STAFF REPORT

DEVELOPMENT REVIEW COMMISSION - VARIANCE REQUEST PUBLIC HEARING

CASE NO.: 20-11000022 PLAT SHEET: G-26

REQUEST: Approval of a Lot Line Adjustment with a variance to lot width on one lot from 45 feet to 40.86 feet, and variances to side yard setbacks for the existing house from 5 feet to 0 feet for the structure and from 2 feet to -2 feet for the roof and a variance to required off-street parking to create a buildable lot and allow the existing house to remain in the NT-1 zoning district.

Attachment B — Plat

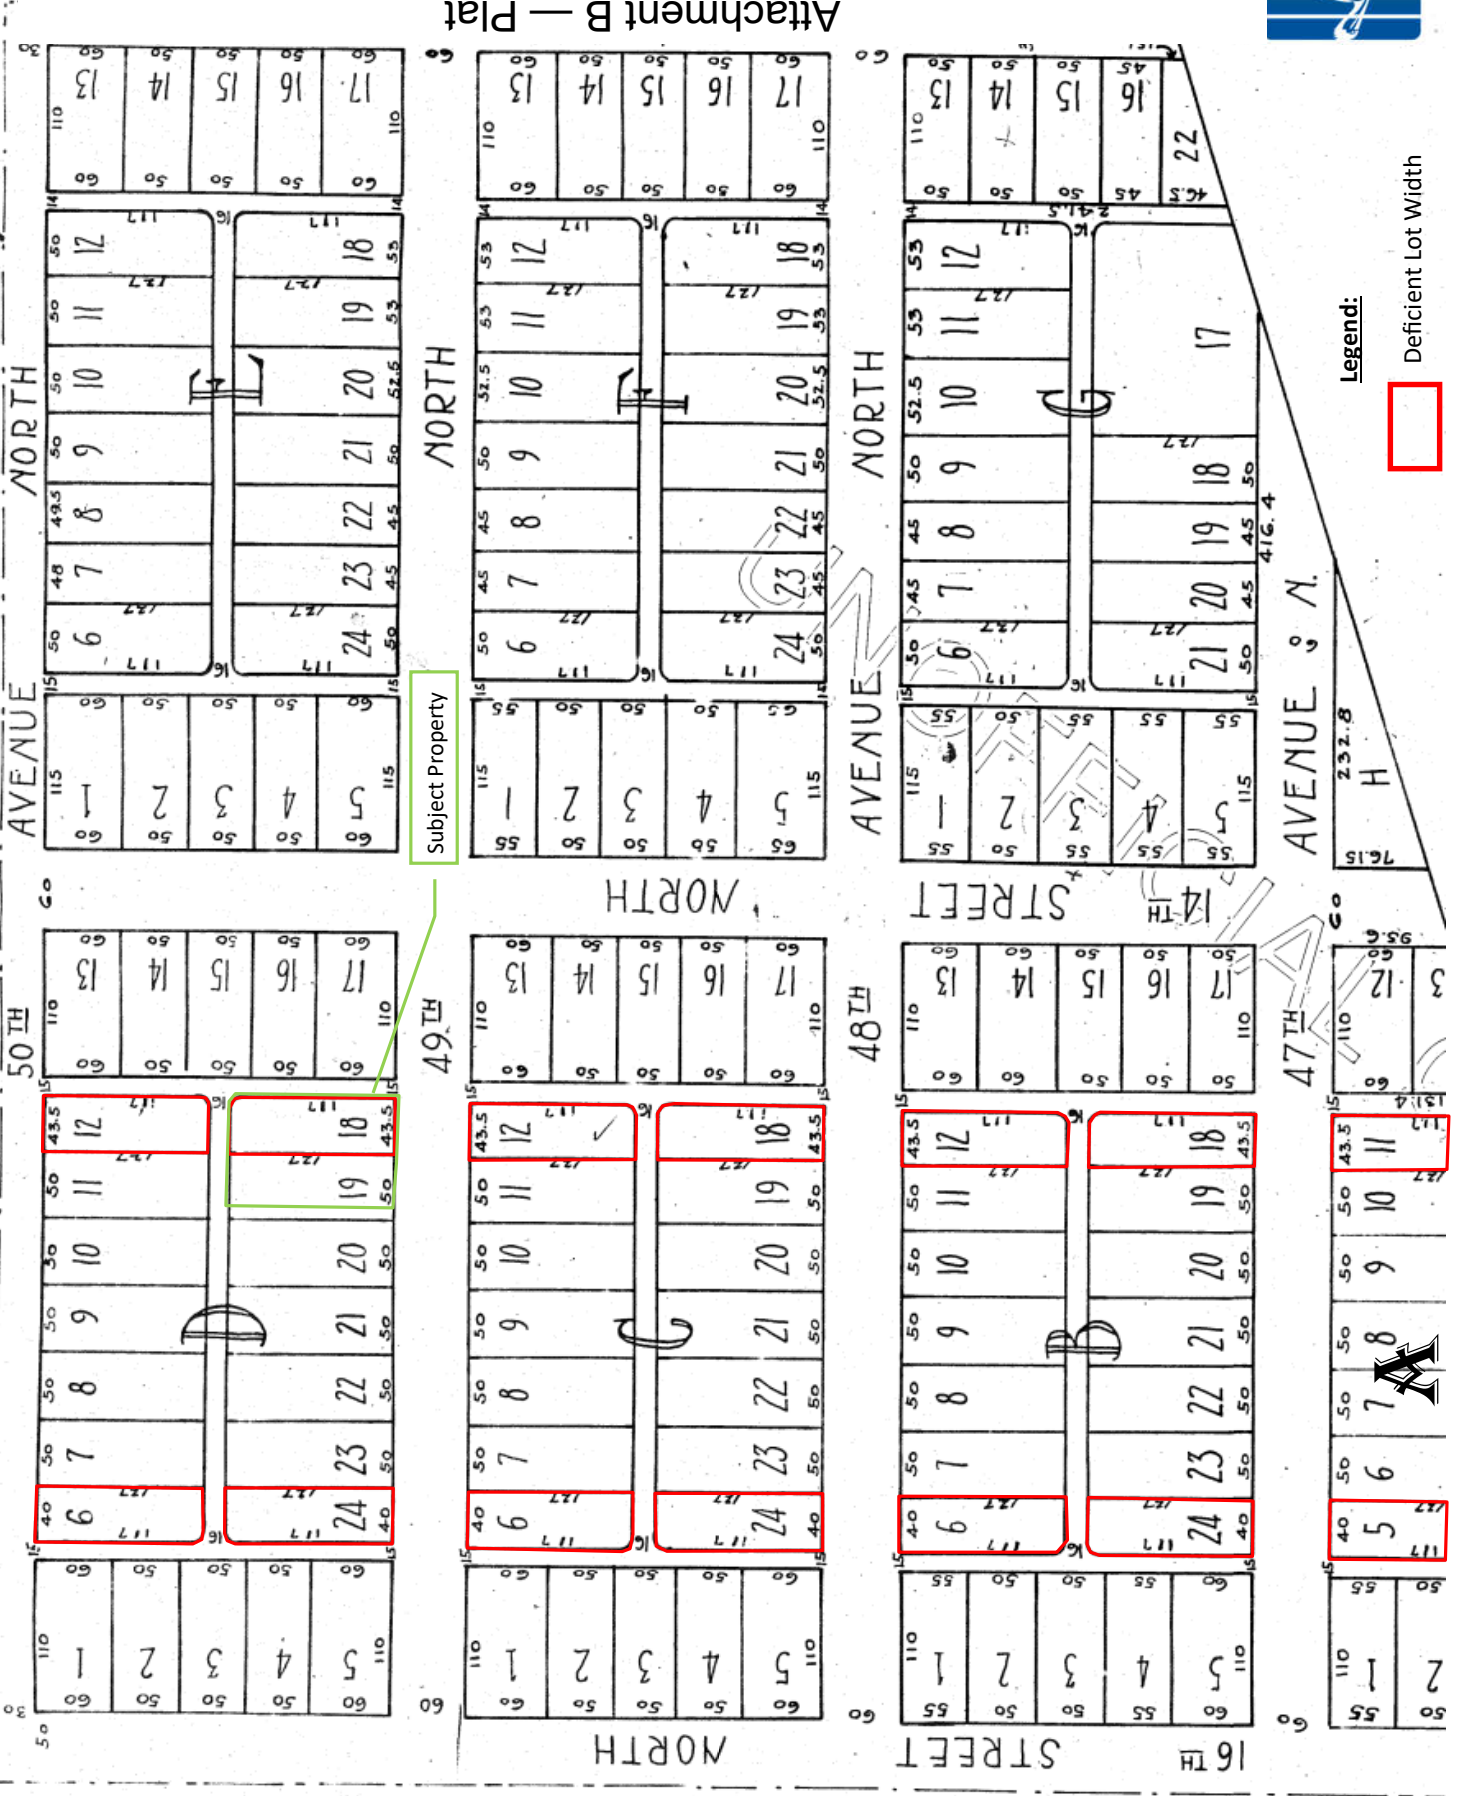
BACKGROUND: The subject property contains one (1) platted lot and a portion of a second platted lot which are currently combined under one Parcel ID Number and contain one single-family dwelling in the Neighborhood Traditional -1 (NT-1) Zoning District (see Attachment A – Location Map). Lot 18 was originally platted at 43.5 feet by 127 feet (with a northeastern corner alley dedication) and Lot 19 was originally platted at 50 feet by 127 feet, however the western 7.2 feet were sold to the owner of adjacent Lot 20 by a previous owner, making the current parcel only 86.3 feet wide by 127 feet deep (see Attachment B – Plat).

- Staff reviewed the lot width variance in terms of consistency with the established neighborhood pattern. The neighborhood was established the by Grovemont subdivision where 14 lots in the A through D Blocks were platted at less than 45 feet wide, although a majority were platted at 50 feet wide and greater (see Attachment B - Plat). Seven (7) lots in block positions similar to that of the subject property were platted at 43.5-feet-wide, and seven (7) lots at the opposite ends of the blocks at 40 feet wide.

SITE PLAN - LOT LINE ADJUSTMENT

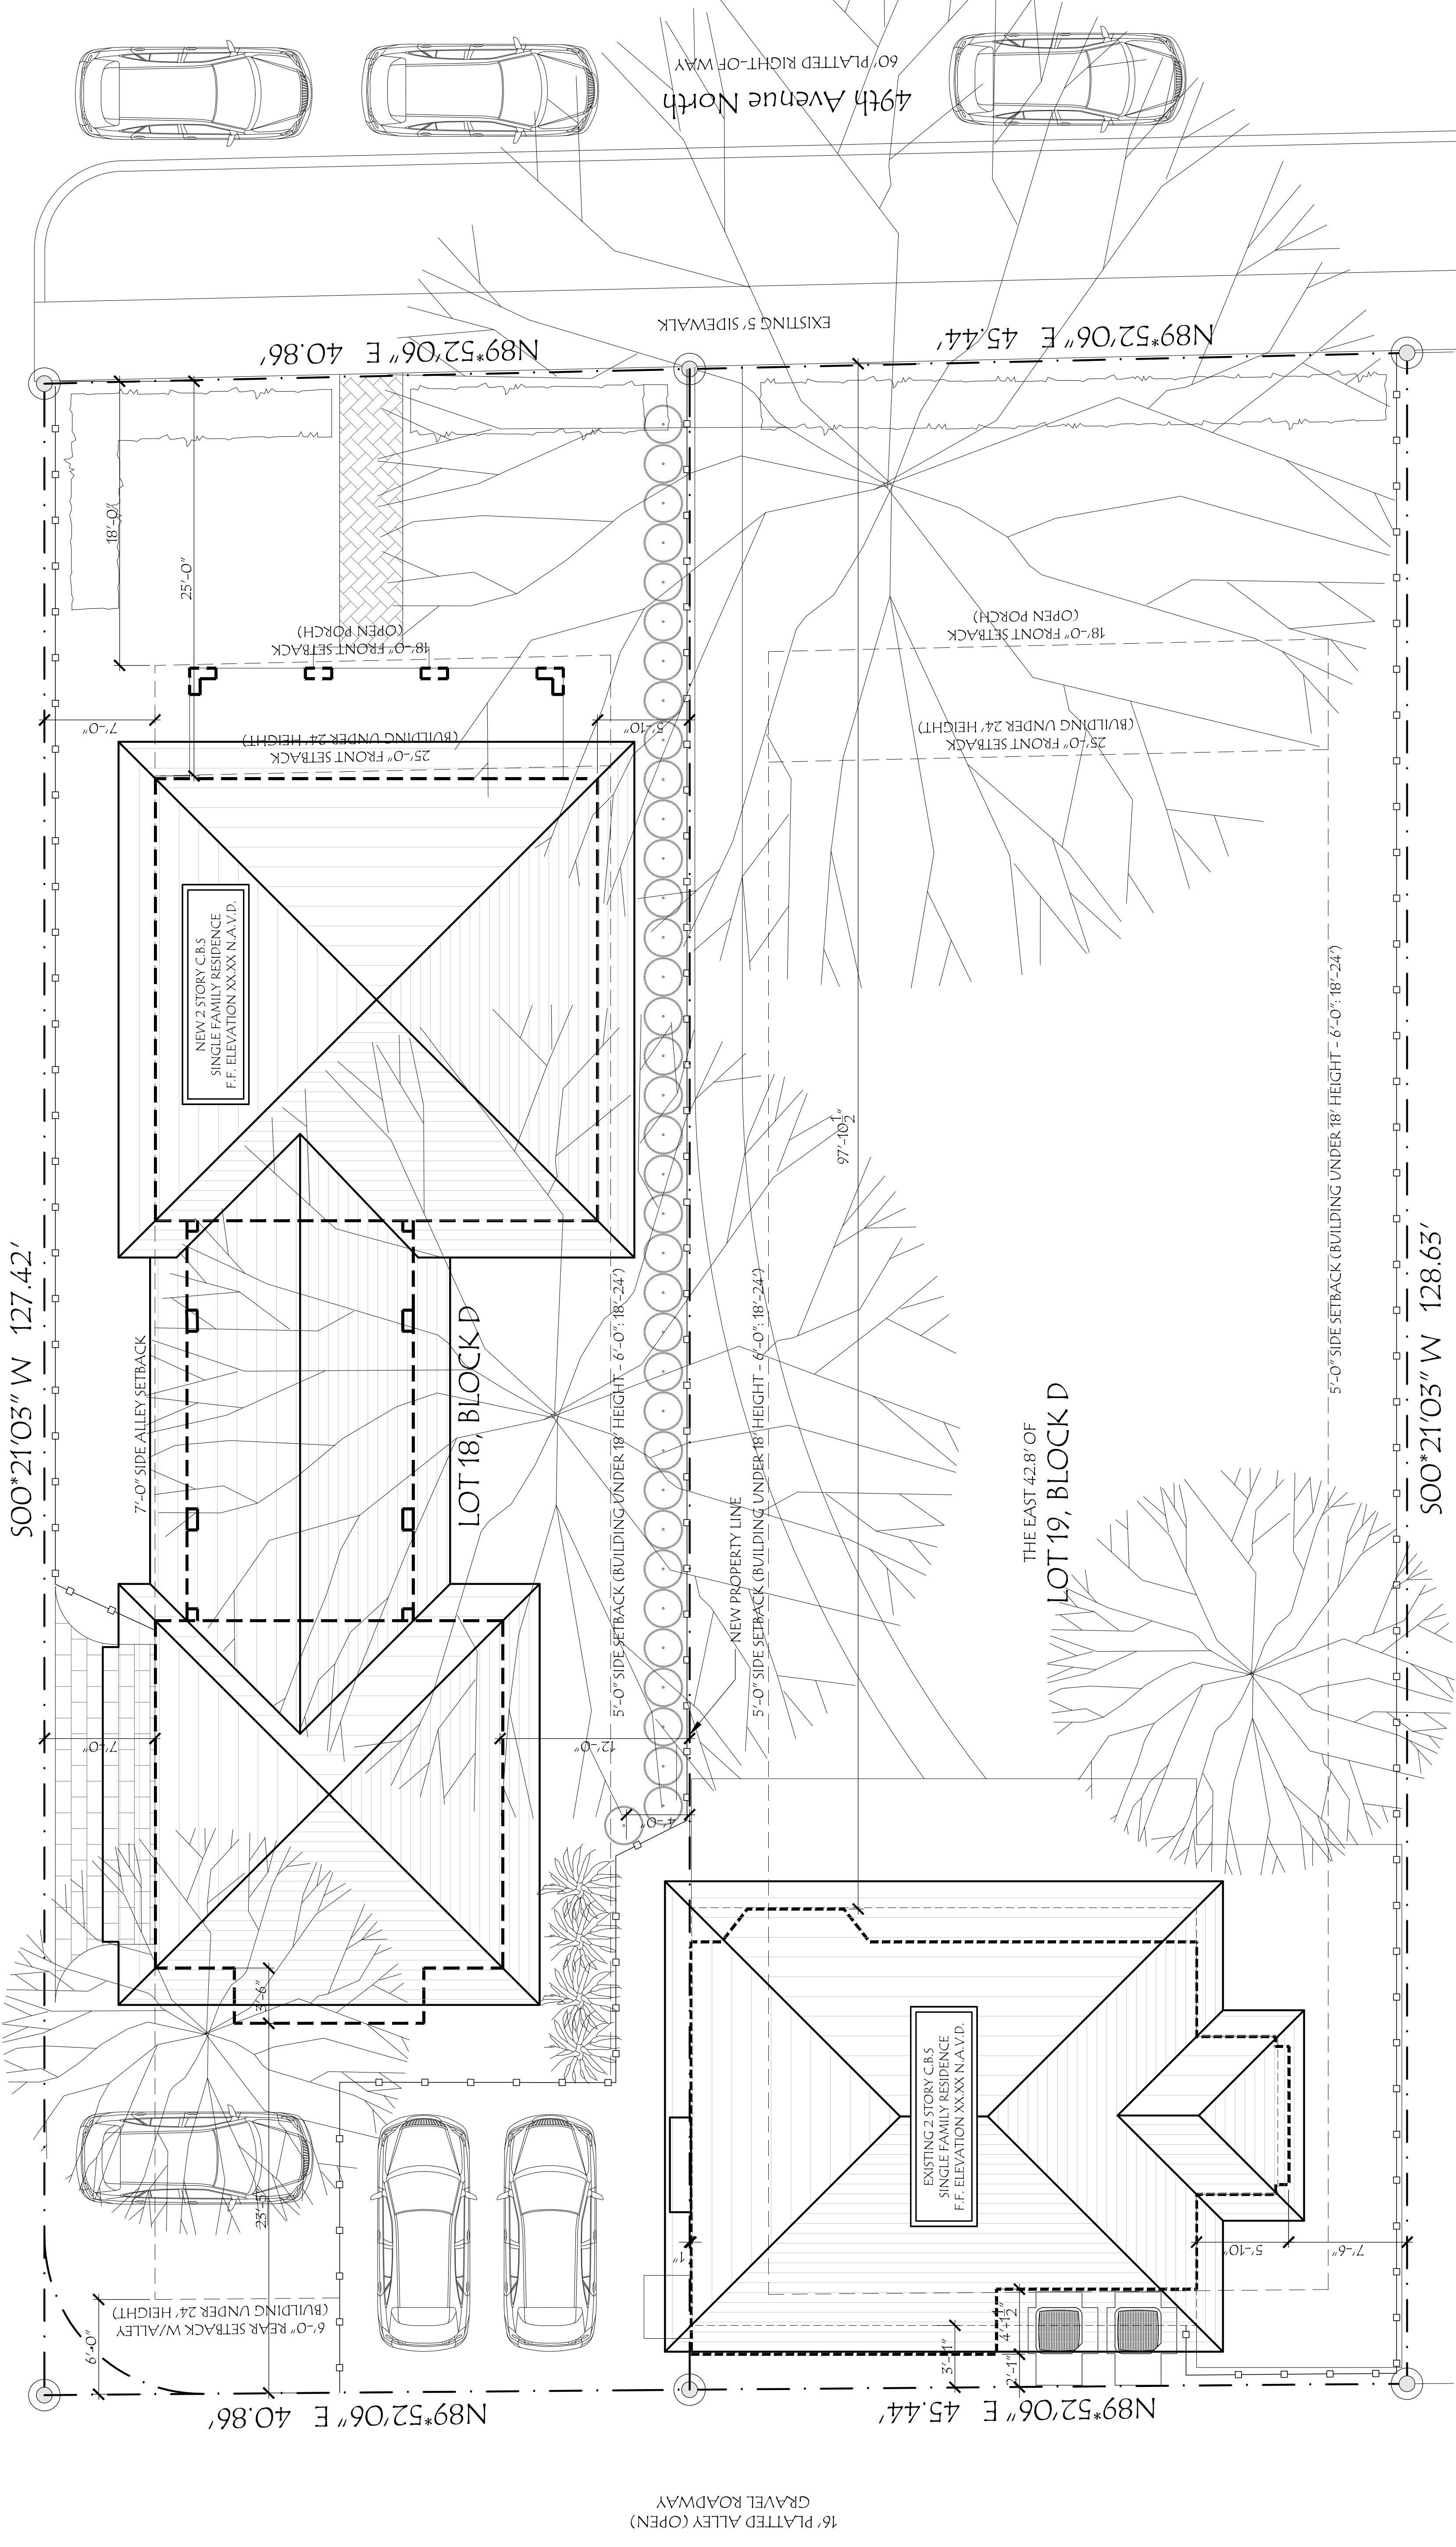
- There is less justification, however, for the building setback variance for the existing house. We see no examples of this in the neighborhood. Although a private easement can be established and would be required for the encroachment as well as for the required off-street parking, this is not a scenario we can support with no clear timeframe to a cure and no larger public interest at stake. It is a self-created hardship. The applicant was pressed during several pre-application meetings to create a more enforceable plan of action to demolish the existing house but has thus far offered none.

- a. *Redevelopment. If the site involves the redevelopment or utilization of an existing developed or partially developed site.*
 - The applicant's plan to retain the existing house while a new house is constructed is driving the need for a building setback variance and the request for an off-site parking area. The applicant may consider this a temporary variance situation, however has provided the City with no timeline or enforcement mechanism for demolition of the house.

- Also, if the existing house were not a factor, deficient Lot 18 could be widened an additional 0.44 feet, bringing it marginally closer to conformity, to 41.3 feet.

STAFF RECOMMENDATION: Based on a review of the application according to the stringent evaluation criteria contained within the City Code, the Planning & Development Services Department Staff recommends **APPROVAL** of the variance to minimum lot width and **DENIAL** of the requested variance to side yard setback.

1. A separate Legal Description and Sketch for each lot is required. A combined sketch is not acceptable.
2. The location of the existing house shall be made conforming and an executed private easement for parking, if found to be still required, shall be submitted to the Staff Planner prior to the issuance of a new Parcel ID number by the County Property Appraiser, and before any zoning or building permit other than a demolition permit is issued.
3. The applicant, successors, or assigns shall comply with the conditions included in the Engineering Department Memorandum dated January 11, 2021.
4. The plans submitted for permitting should substantially resemble those submitted with the approved variance application. Proper permits shall be obtained including a Tree Removal

DWG. No. **S30-5**

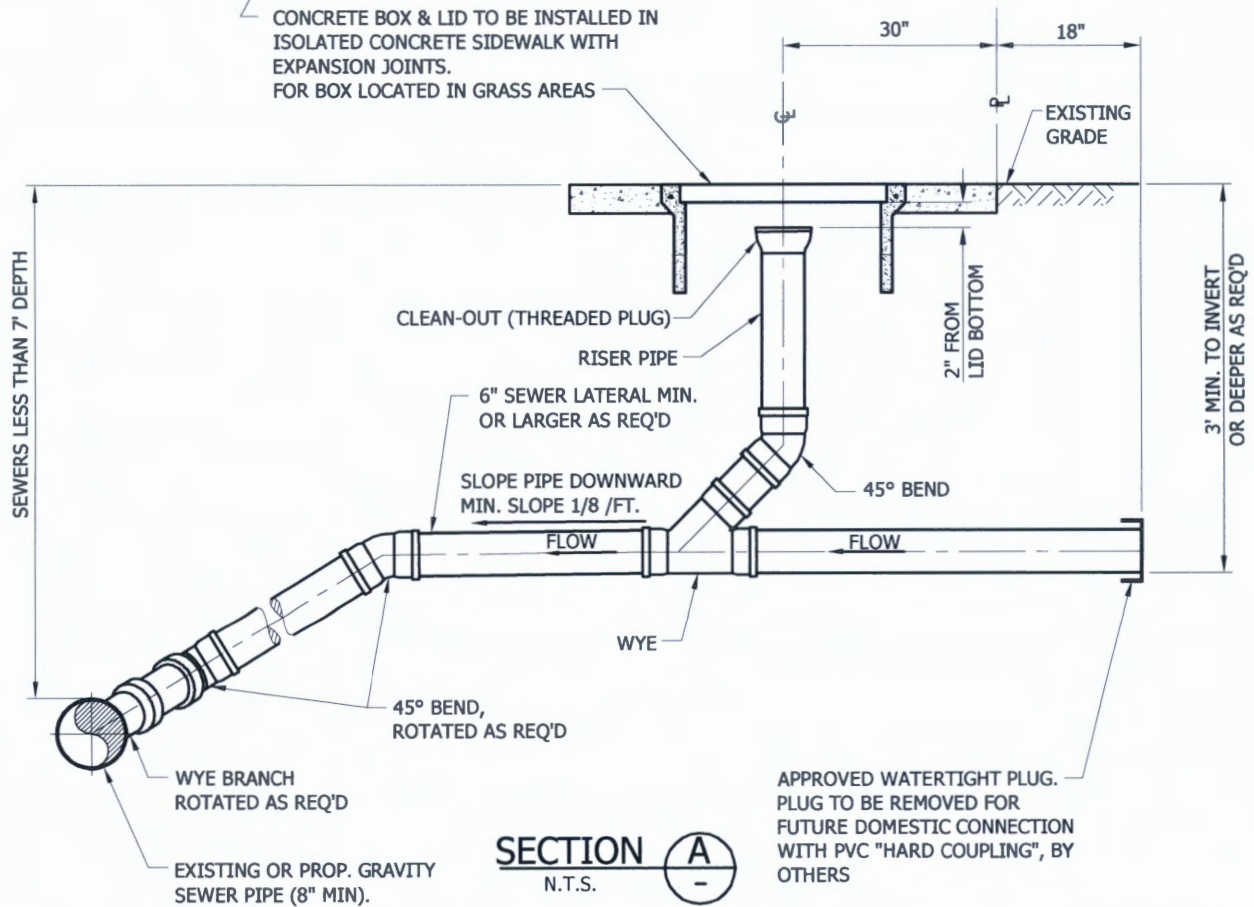
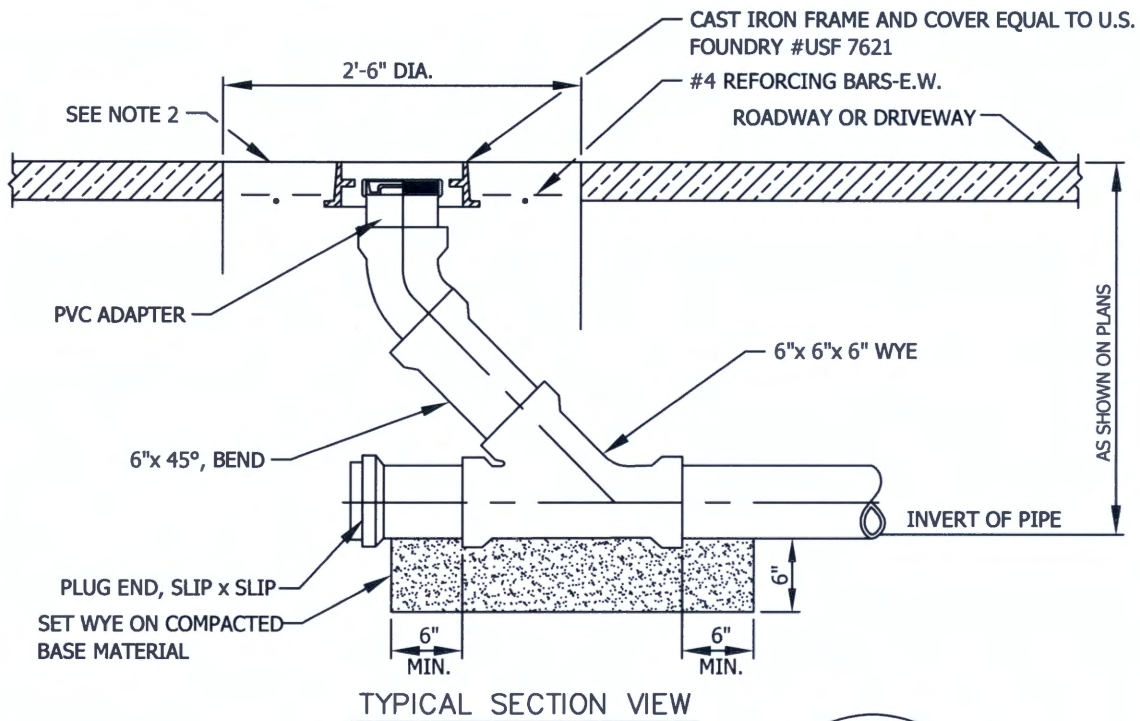
- a. The applicant/property owner is required to provide a public sanitary sewer service lateral and connection to the public wastewater collection system per current City ECID standard detail S30-5, S30-7, S30-9 & S30-50. The minimum size public sanitary sewer service lateral for an individual residential property is 6". All cost for design, permitting, and construction of a new public service lateral(s) shall be by and at the sole expense of the
